ADDENDUM No. 4

- A. The Construction Contract is known as: *Mountain Green BNR Wastewater Treatment Plant*
- B. Date of this Addendum: 2/10/2023.
- C. All other provisions in the contract to remain in full force and effect.

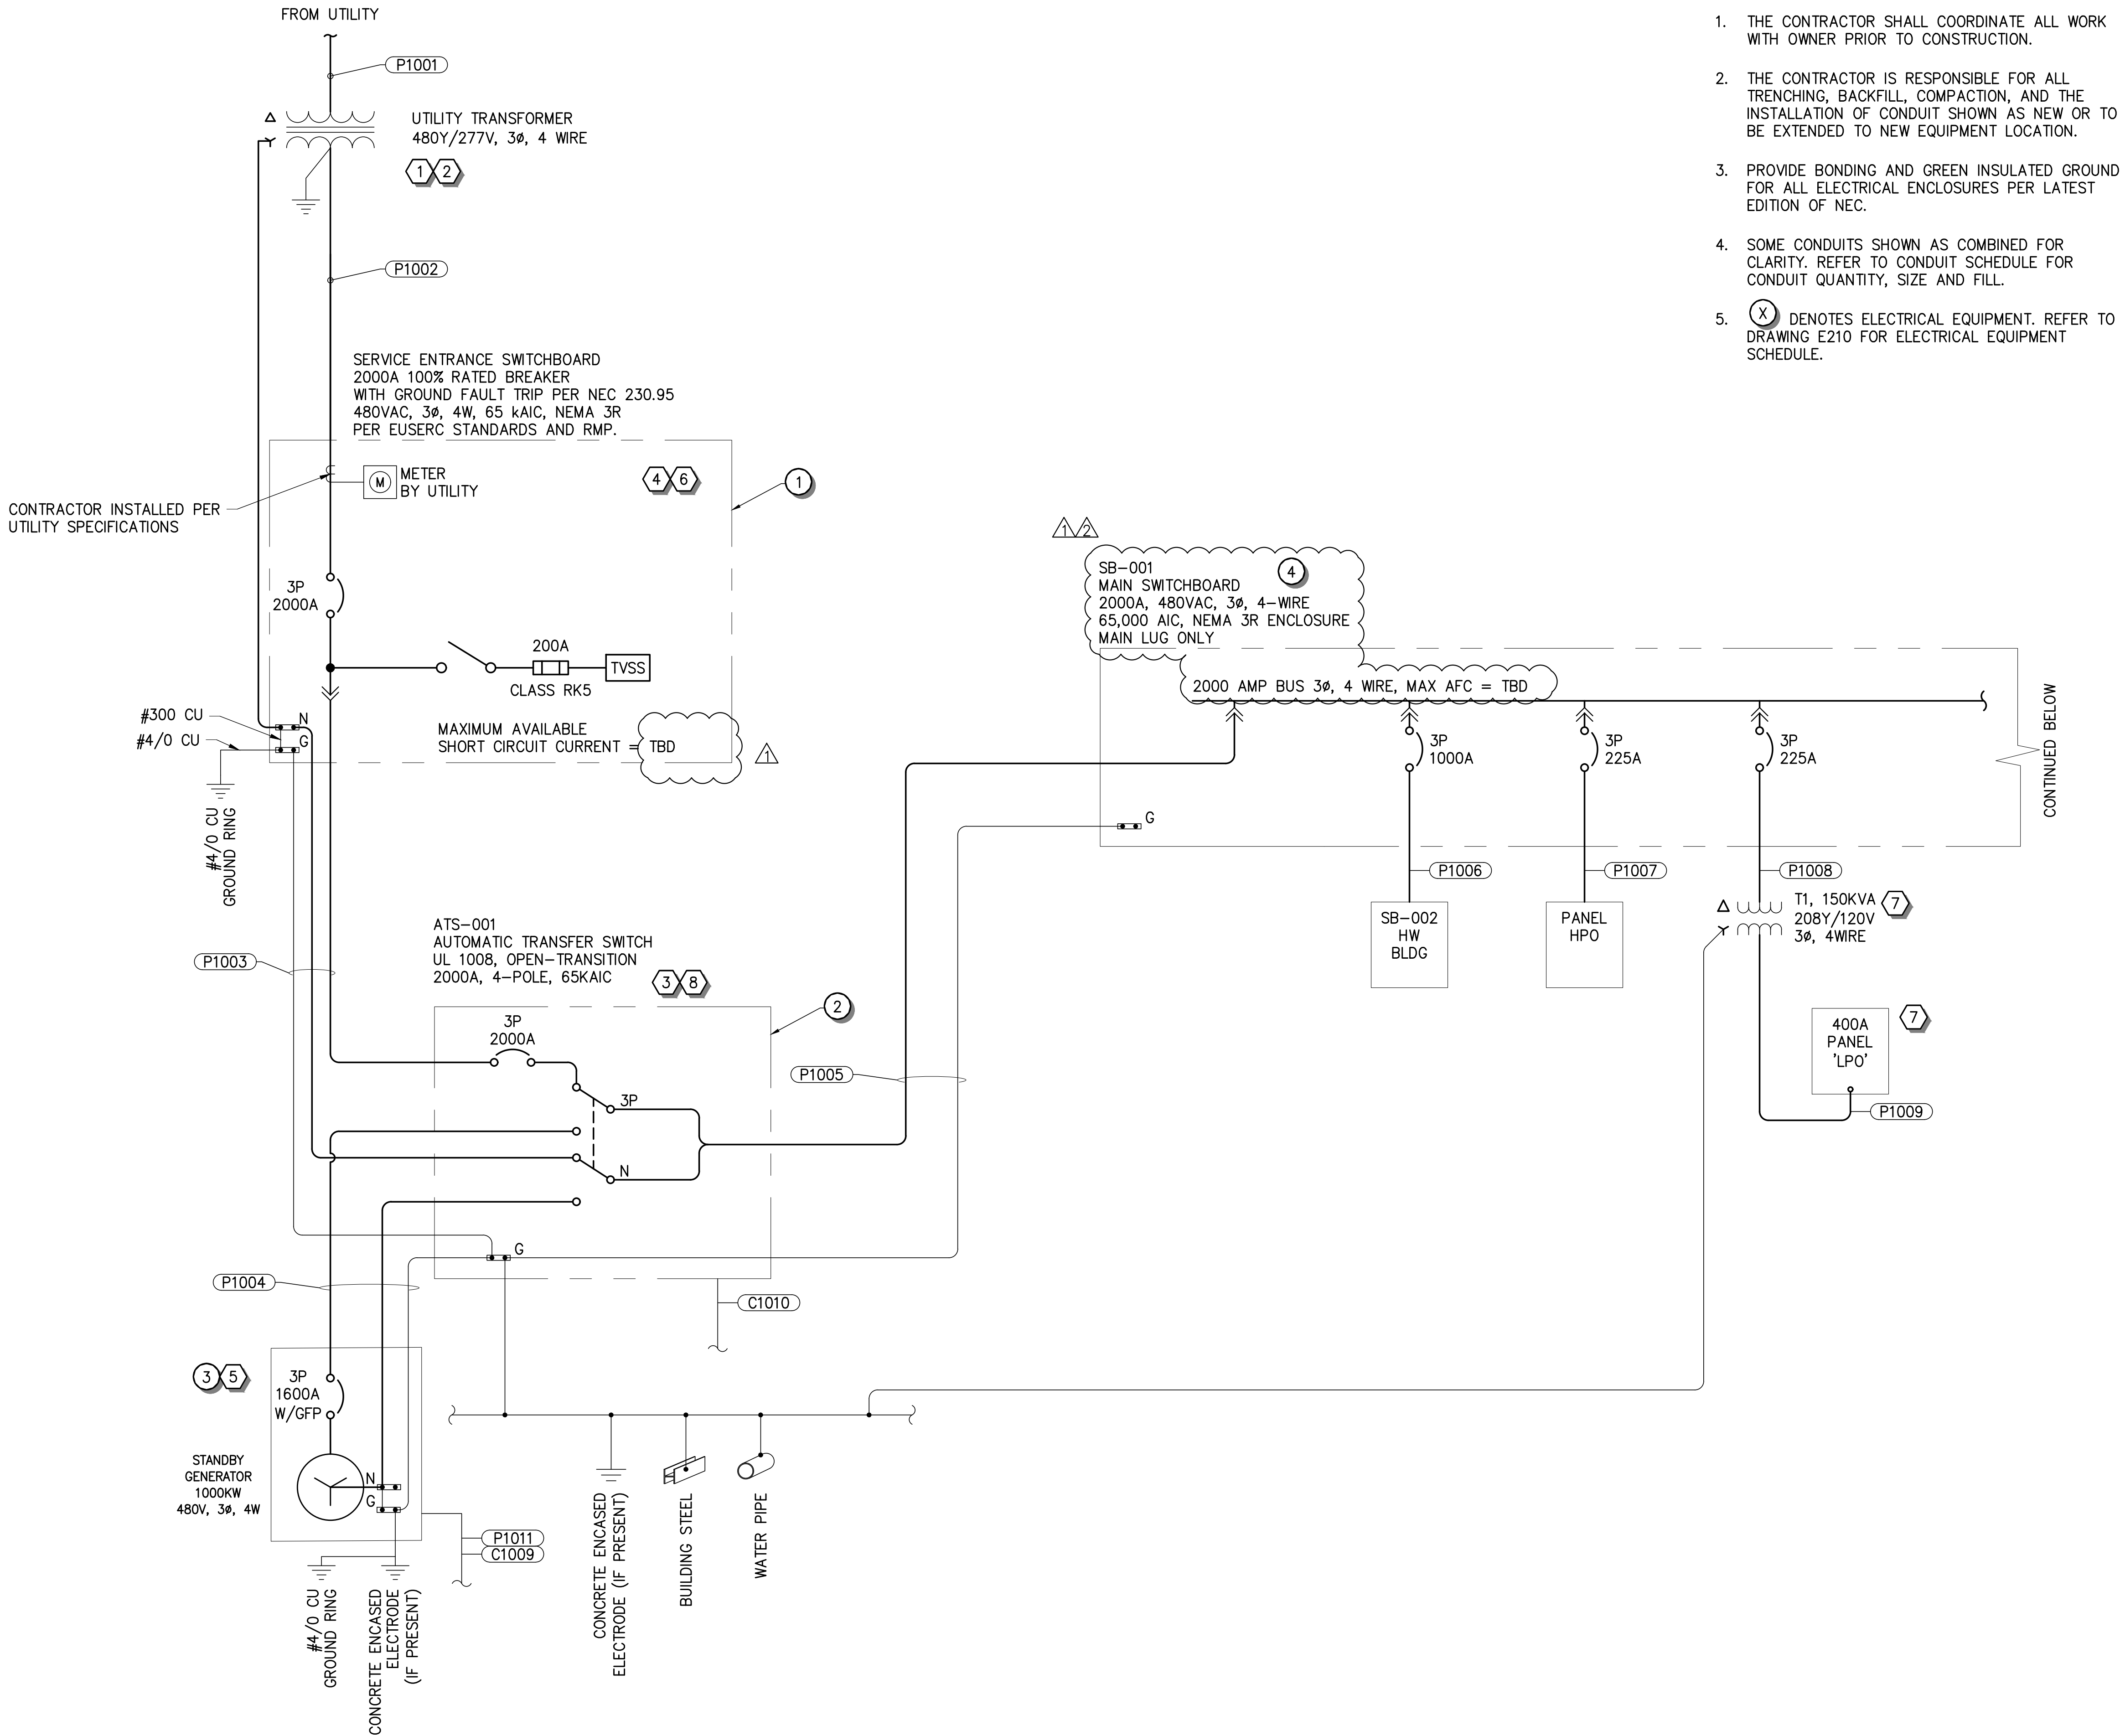
Response: Generator is to be supplied by Contractor per Specification 16817SP. Key Note #5 on Drawing E201 had been corrected. Generator pad details to follow.

4. PROVIDE SIGN AT METERING SWITCHBOARD INDICATING TYPE AND LOCATION OF STANDBY GENERATOR.
5. GENERATOR PROVIDED AND INSTALLED BY CONTRACTOR. CONTRACTOR TO PROVIDE AND INSTALL CONCRETE PAD PER MANUFACTURER'S RECOMMENDATIONS.

SEI NO.	DESIGNED	DRAWN	CHECKED	SHEET NO.	E-307
S08242	JRK	JRK	JRK	178 of 249

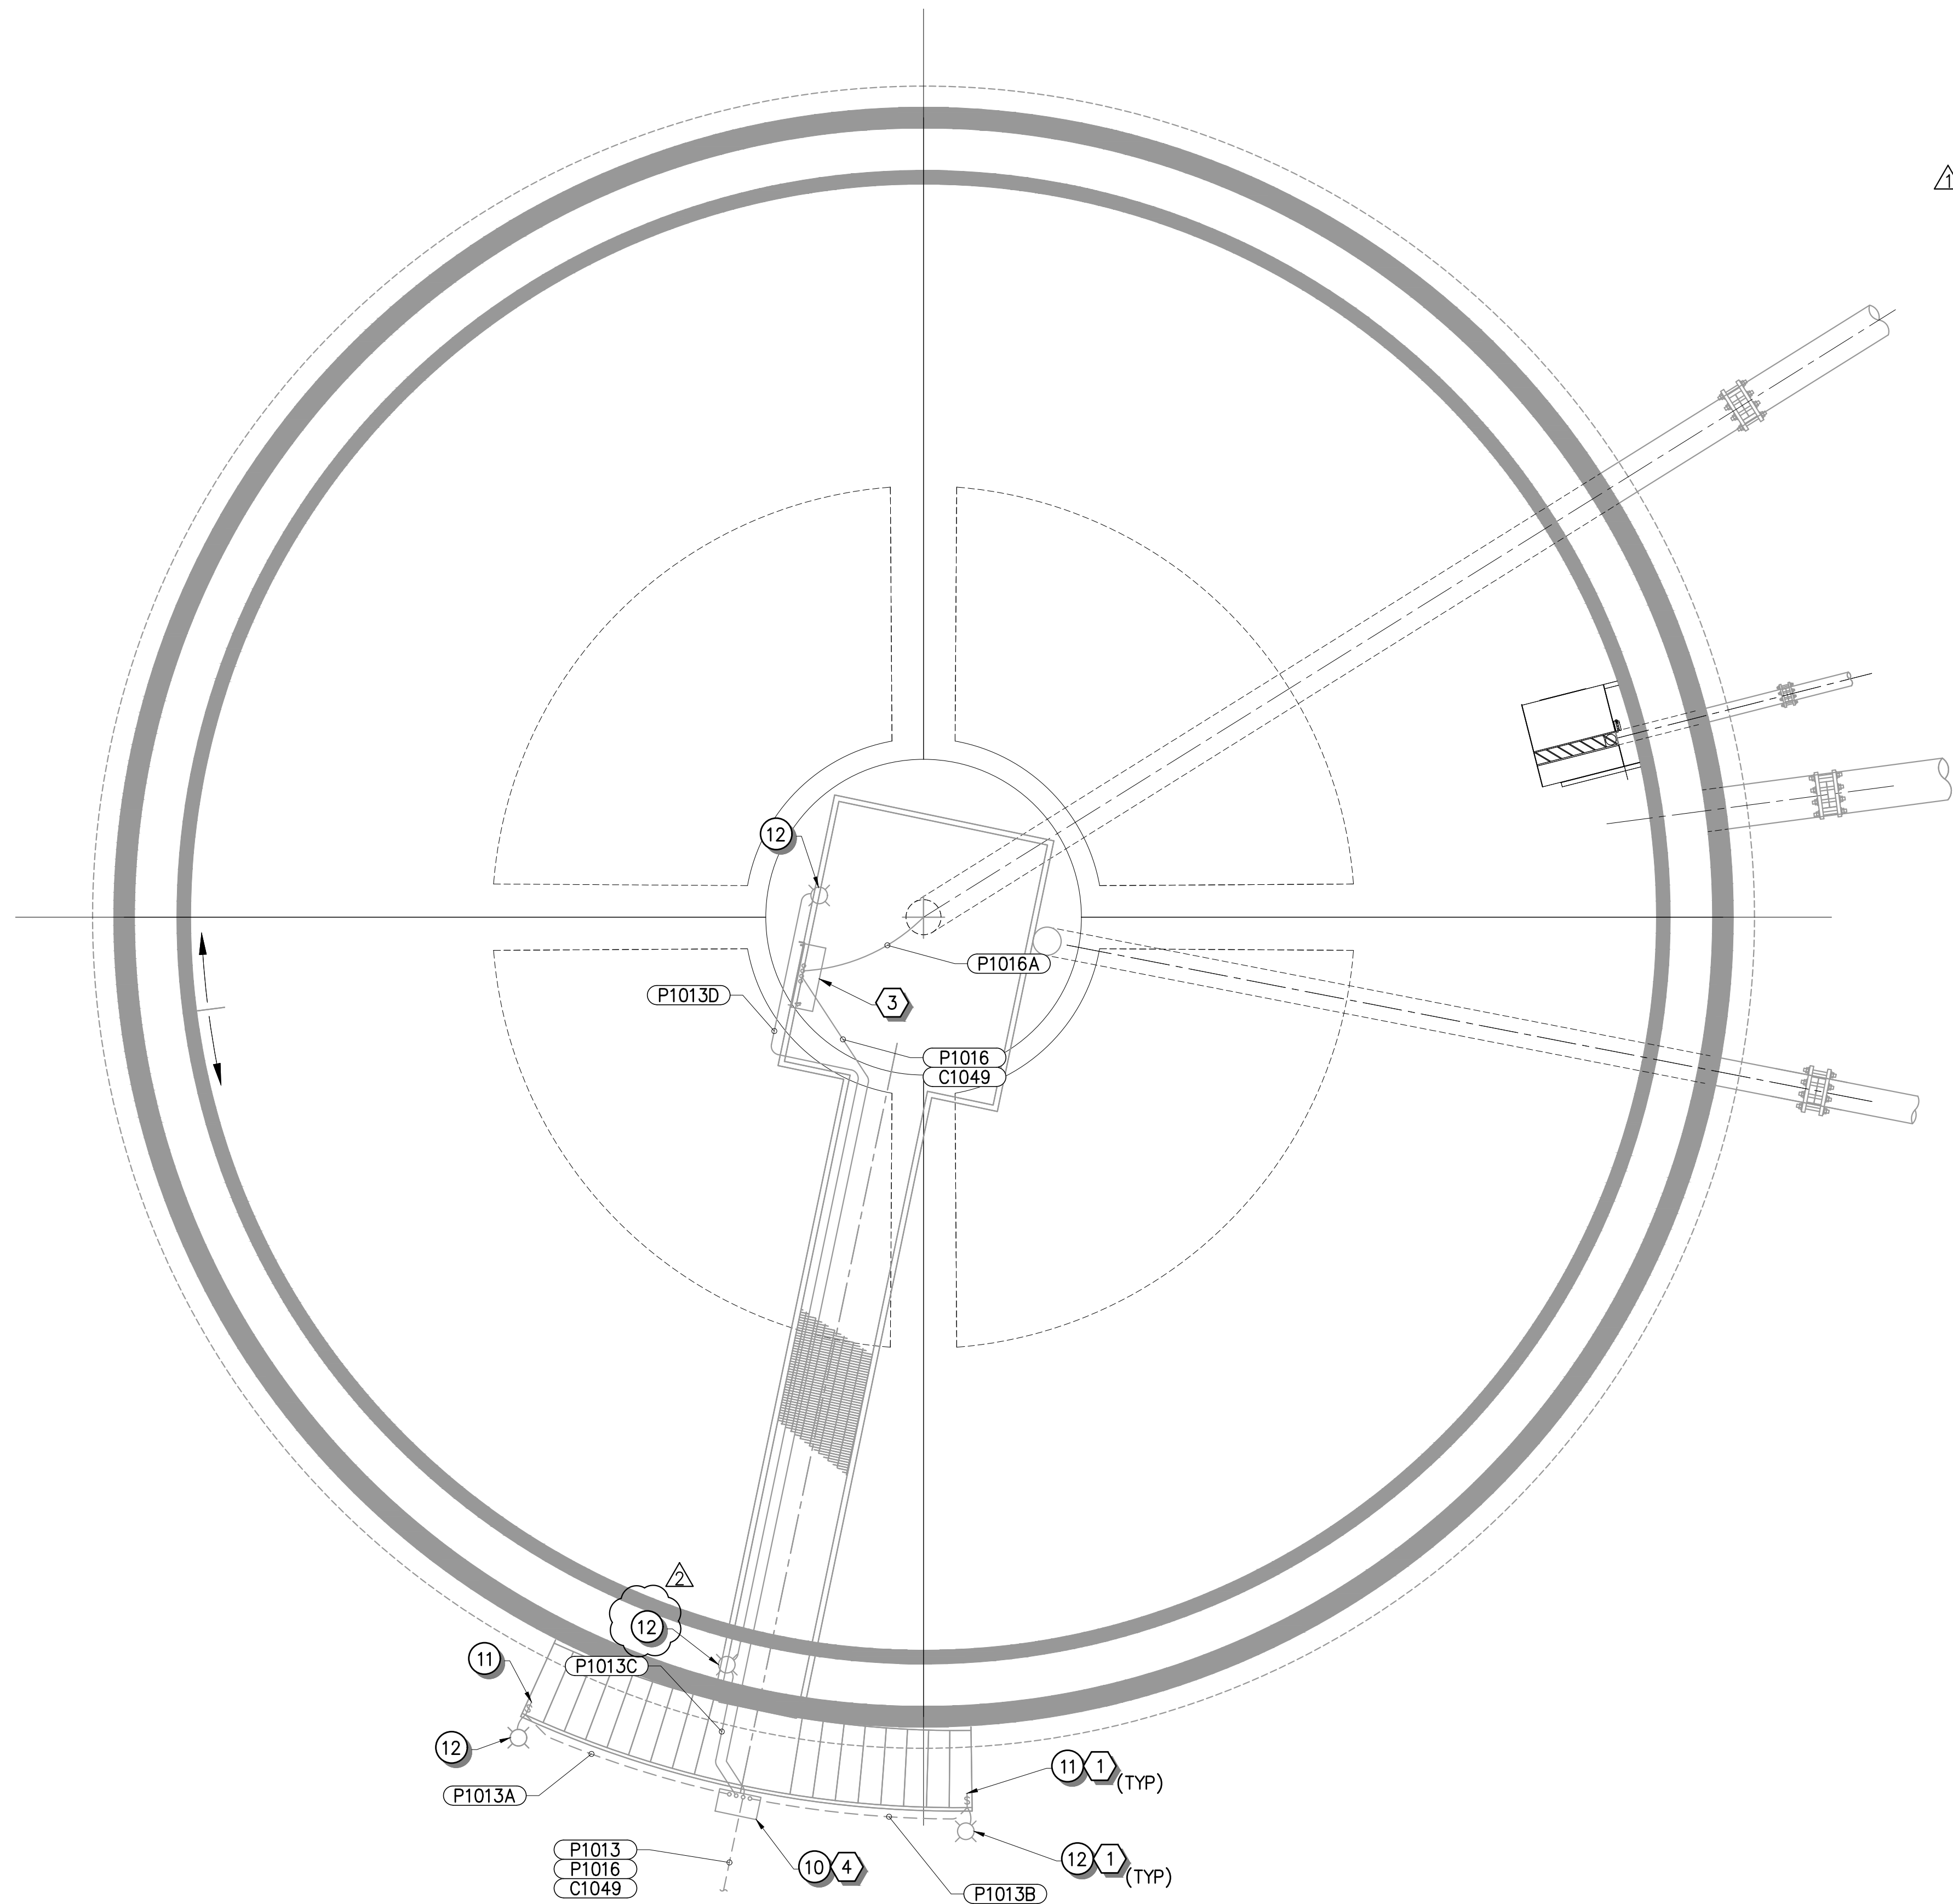
- 1) Drawings E-307, E-308, E-403, E-406, have an incorrect scale. Please correct and reissue.

Per addendum #3, drawing scale for E307 should be 1" = 60" (5'), not 60'.

MOUNTAIN GREEN SEWER IMPROVEMENT DISTRICT				
BNR WWTP 2022				
HP POWER AND CONTROL PLAN				
SEI NO. S08242	DESIGNED JRK	DRAWN JRK	CHECKED JRK	SHEET NO. 182 of 249
				E-403

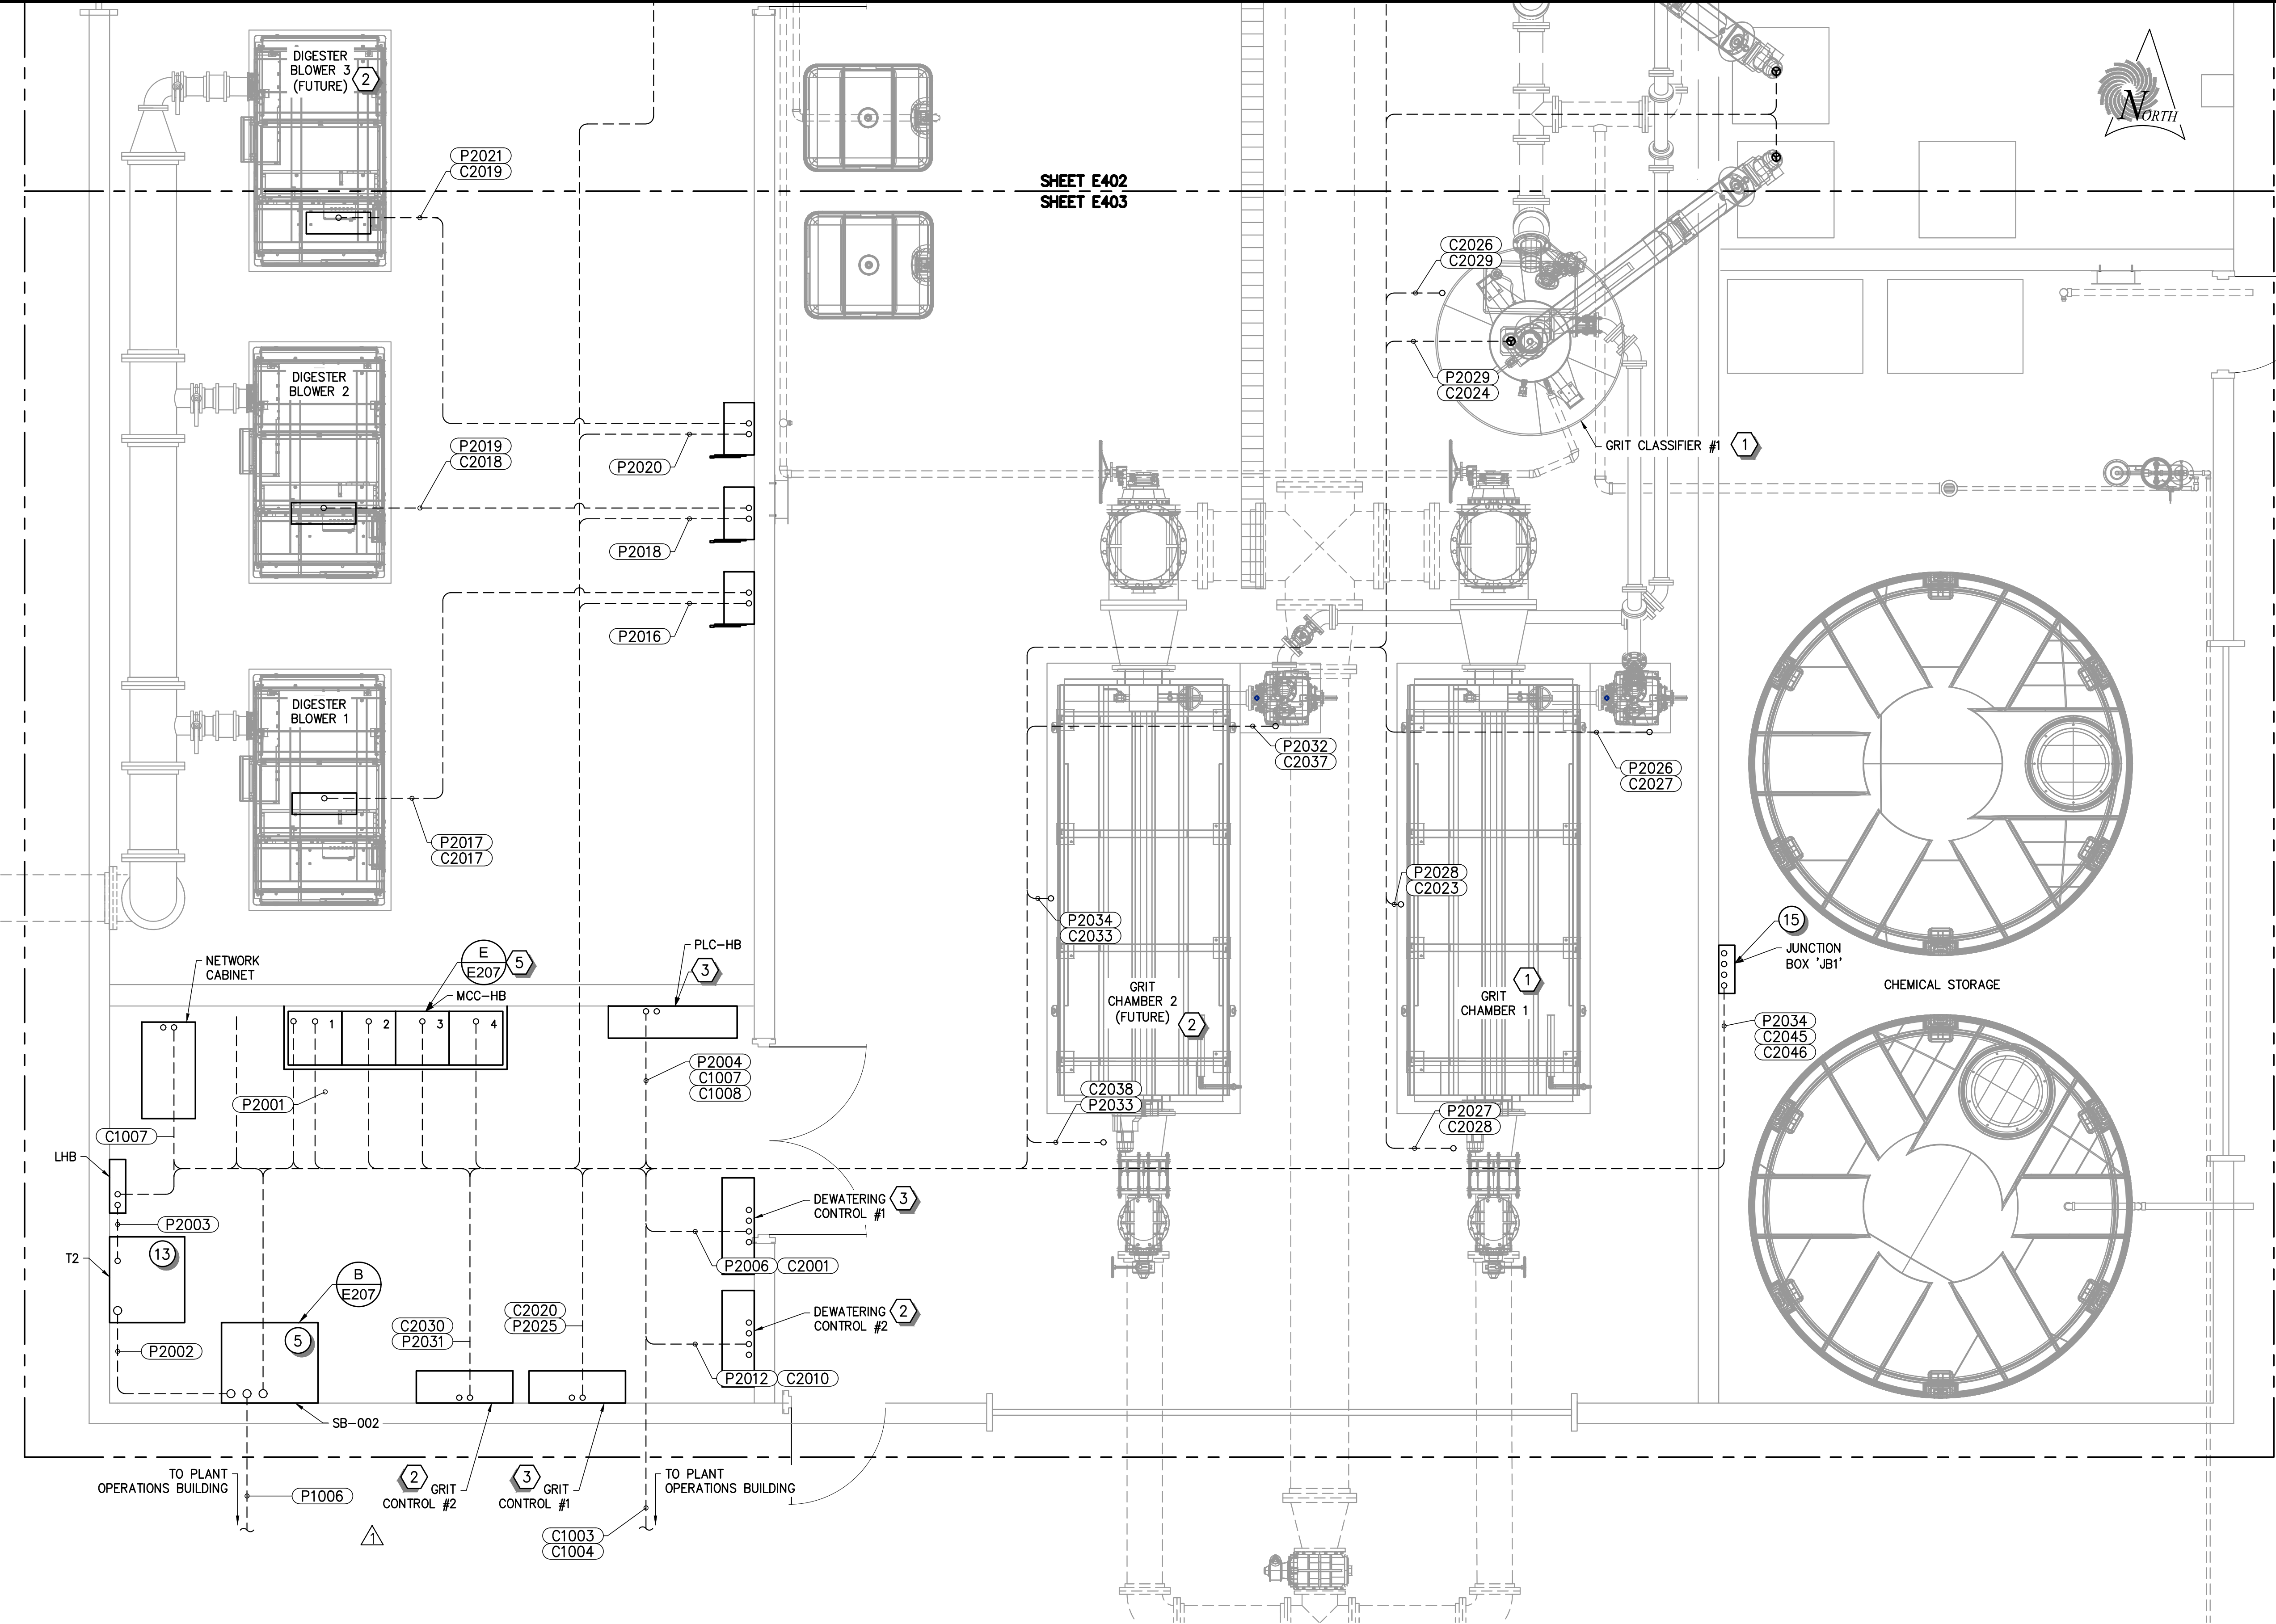
2) Concerning drawing HW-AE-101 verses E-403. These drawings show panel LHB in contradicting locations.

Response: Electrical Panel exact location is flexible, but should be located in Electrical room as shown on both Sheets. Preferred location is near the transformer as shown on Sheet E403.

Drawings E403 and E406 have been corrected to show 3/8" = 1'
